Product Change Notification

Change Notification #: 116123 - 00

Change Title: Intel® Server Chassis R1304WFXXX and R2000WFXXX, Intel® Server Systems R1304WFTYS, R1304WF0YS, R1208WFTYS, R2308WFTZS, R2208WF0ZS, R2208WFTZS, R2208WFQZS, R2312WF0NP, R2312WFTZS, R2312WFQZS, R2224WFQZS, R2224WFTZS, PCN 116123-00, Product Design, Order Code, Rear panel and rear brackets new design

Date of Publication: February 27, 2018

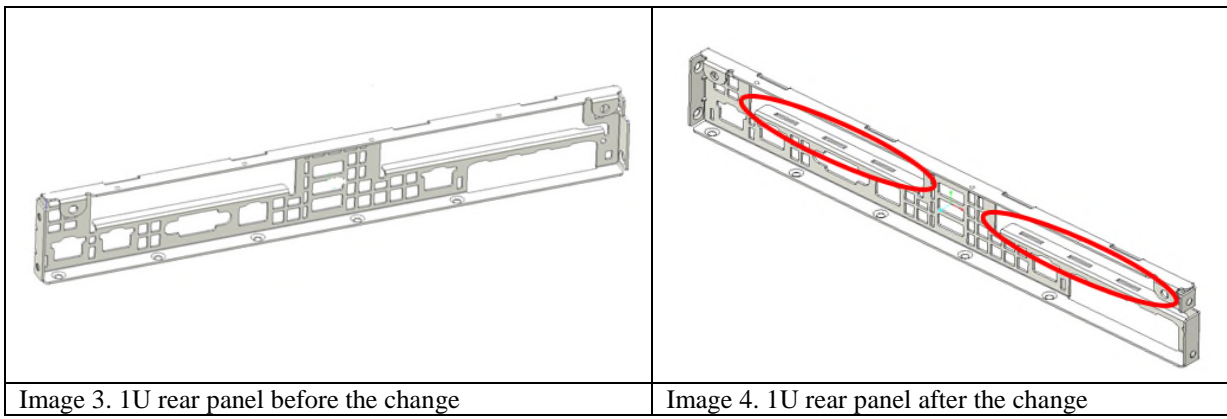
1. Change the design of the left rear bracket

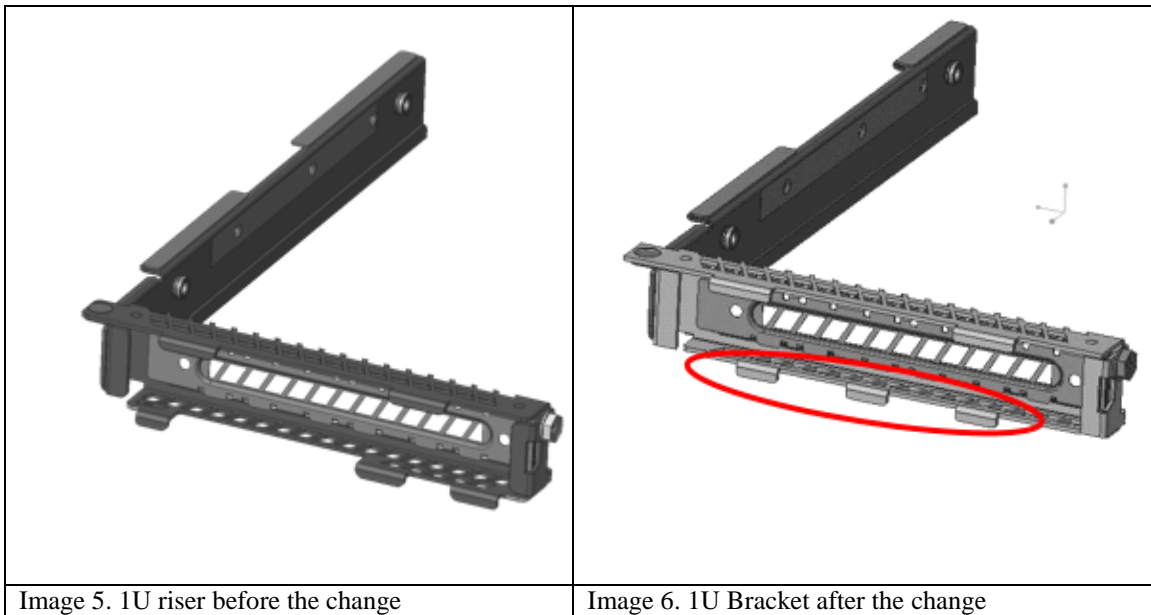
2. Adding holes to the rear panel

Image 7. Rear Panel before the change

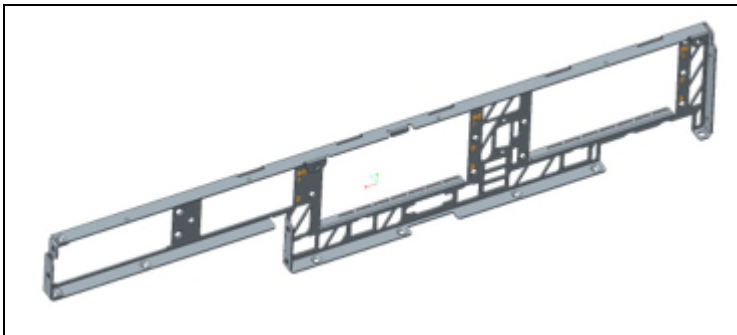
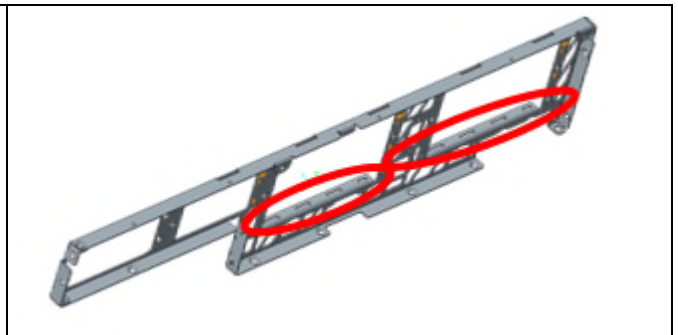
1. Adding holes to the rear panel.

Image 9. Rear center bracket before the change

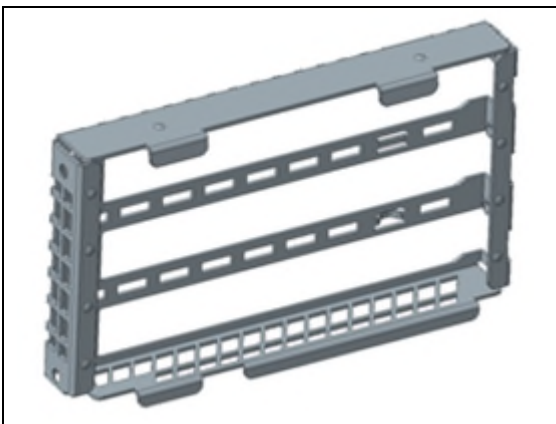
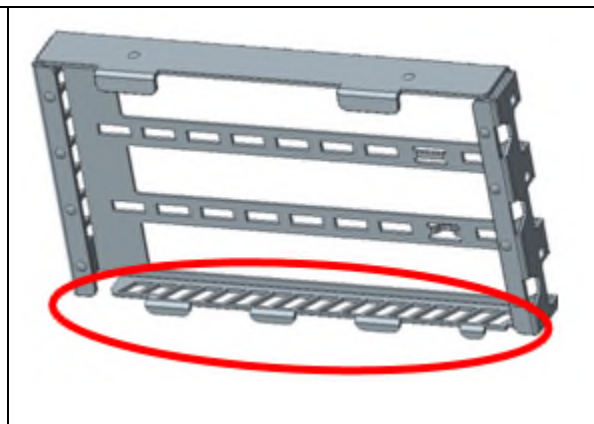
2. The center rear bracket has a new design

Image 11. Bracket before the change

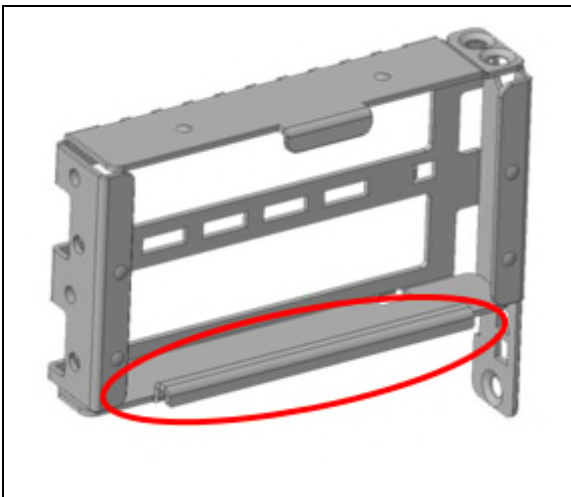
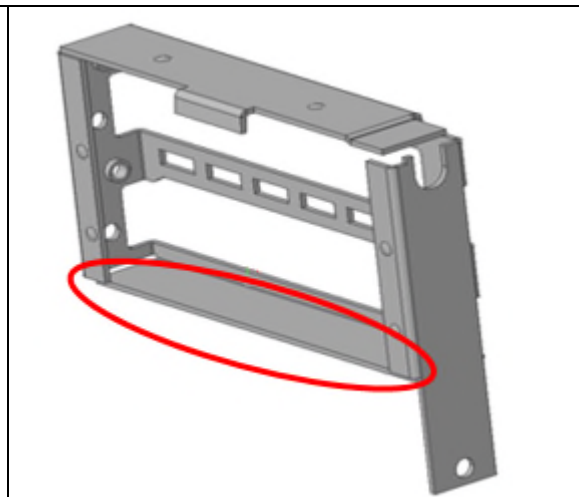
3. Remove the stopper of the left rear bracket on the rear panel

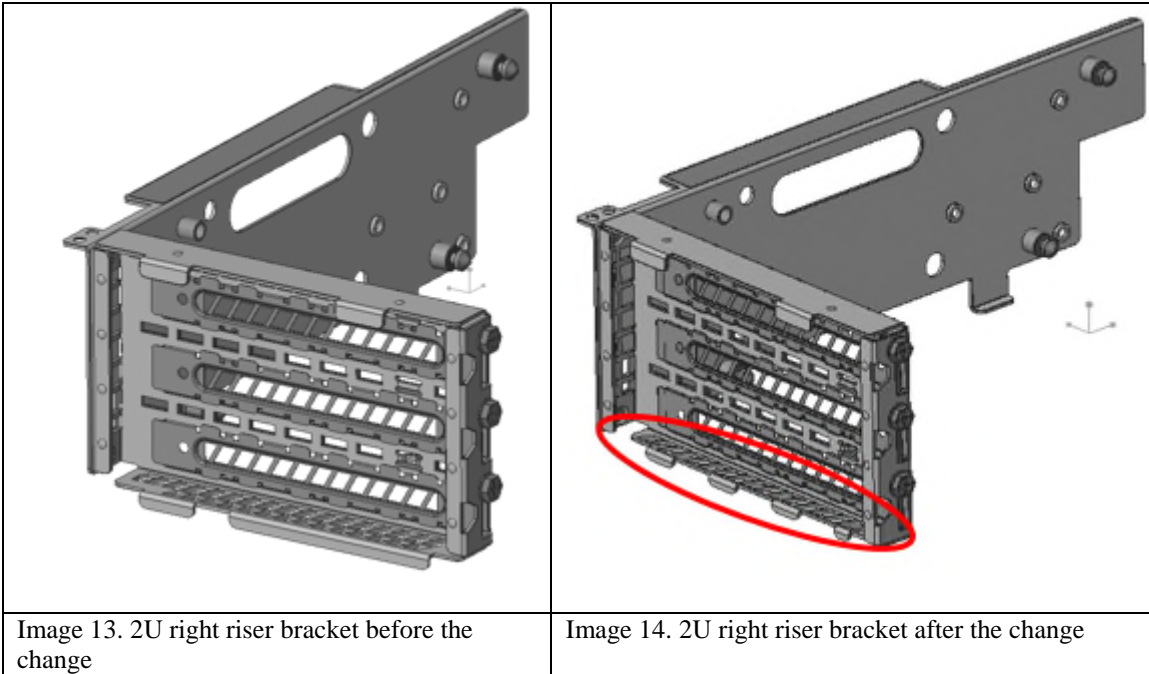
4. The right riser bracket has a new design.

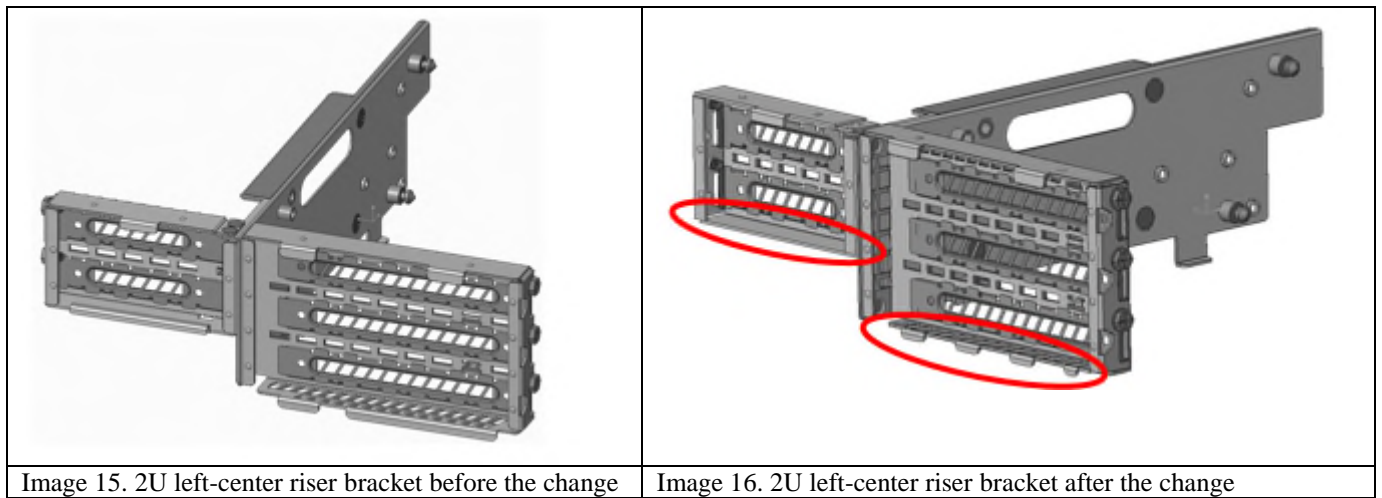
5. The left-center riser bracket has a new design.
